**PRC ENGINEERING PACKAGE**

**EP No: ECR-19-001330 Rev 00**

**EP Title: RO-RO Liner Box - Update Sketch**

Develop a design for expanded metal grating offsets that can be installed inside of the RO/RO Liner Box specified on DWG. NO. CEES-12-351-M-017, Sheets 1 through 4 to provide a minimum 2-inch thick separation between the grating and the floor and walls of the RO/RO Liner Box.

| DISCIPLINE ENGINEER              |  | RO/RO Liner Box<br>Grating Install Sketch  |

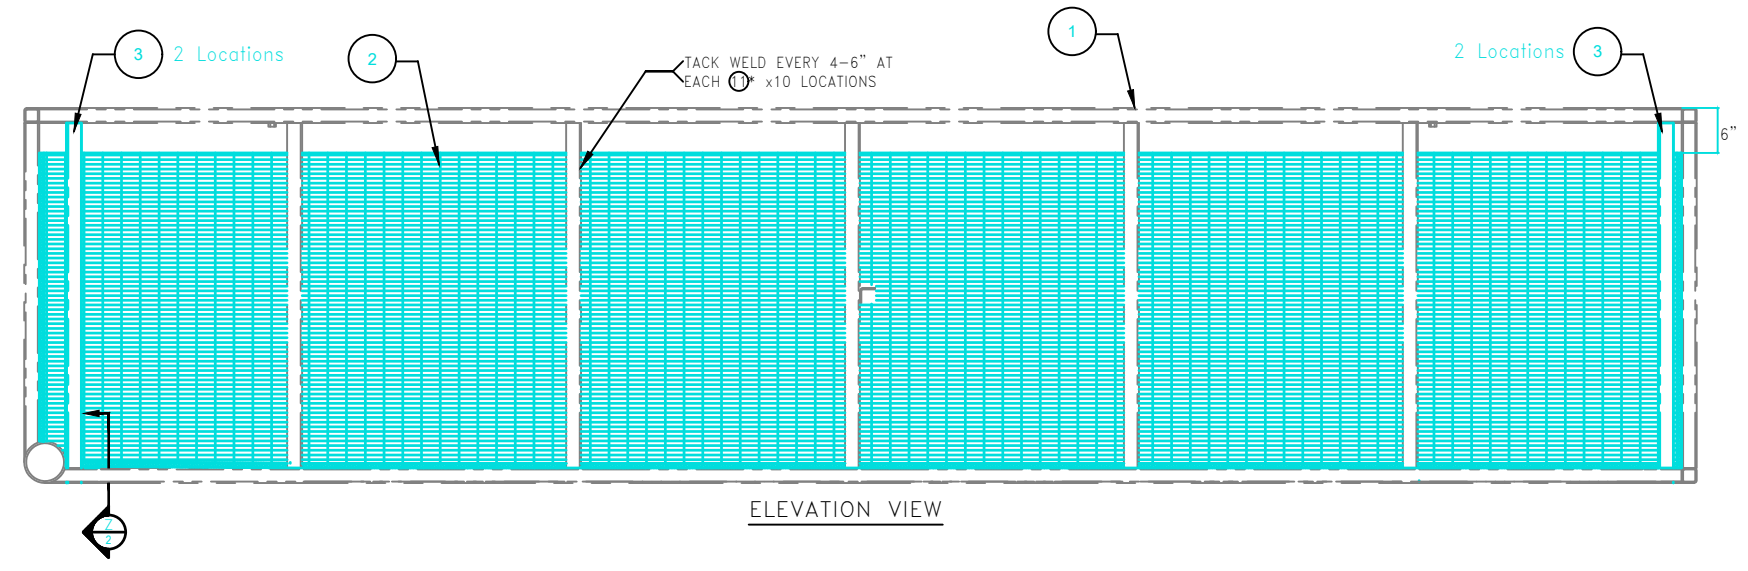
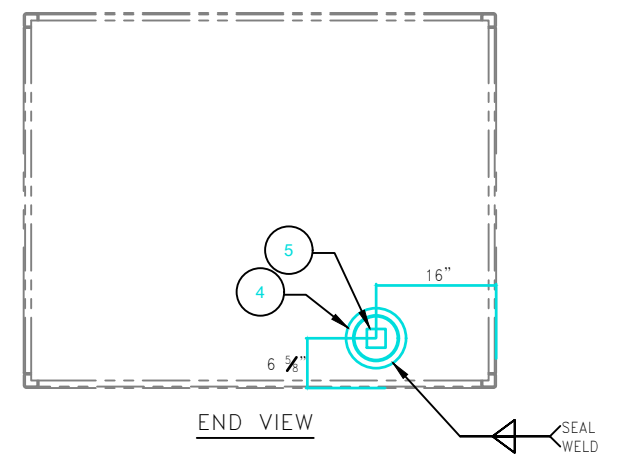
1. THE GRATING IS AN ADDITION TO THE RO/RO LINER BOX DRAWING CEES-12-351-M-017 SHEETS 1-4, AND THE CORRESPONDING SUBMITTAL NUMBER S037528A00-05-004A-034A
2. THE EXTERIOR 12 GAUGE PLATE IS NOT SHOWN COMPLETELY ON THIS SKETCH FOR CLARITY
3. REBAR<sup>®</sup> MUST BE REMOVED AS IT WILL INHIBIT THE PLACEMENT OF THE FLOOR GRATING
4. GRATING SPLICES MUST BE JOINED WITH 3/16" X 2" FLAT BAR AND TACK WELDED AS NEEDED TO KEEP FROM SEPARATING
5. INSTALL A 4" DRAIN PLUG AS LOCATED IN THE "END VIEW" OF THE RO/RO LINER BOX THROUGH THE 12 GAUGE PLATE
6. ANY ITEM NUMBERS CONTAINING ⊗ REFERENCING THE PARTS LIST ON DWG CEES-12-351-M-017 SHEET-1 PARTS LIST

- Grating shall provide 2-inch separation between RO/RO Liner box floor and walls (front, back, and side walls).
- Grating on the RO/RO walls shall be extend from the grating on the floor of the RO/RO Liner Box up to 6-inches from the top of the RO/RO Liner box walls.
- Grating shall be 4.0LB Expanded Metal Grate-X grating - Pacific Steel part No. GE448, GE4510 or Equivalent
- Provide a drain plug located on the back end of the RO/RO Liner Box that will drain liquid out of the box after a 6-inch thick grout floor has been poured.
- The structural components of the RO/RO Box Liner shall not be removed or replaced.
